## LLOYD'S REGISTER OF SHIPPING

S.S. "SEIZAN MARU"  
Smk. Rpt. No. 2610.

Steel ring shrink on.

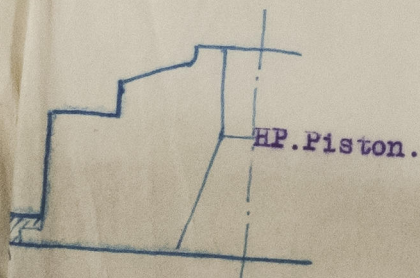
In reply to your classing letter of the 4th July last, I have to say that the H.P. Piston was repaired by part machining off the bottom flange part and shrinking a steel ring on in order to adjust the clearance between the piston and the cylinder wall as shown in the sketch below.

Upon special examination in November last, it was found in efficient condition, however, considered better to examine again at next Annual Survey.
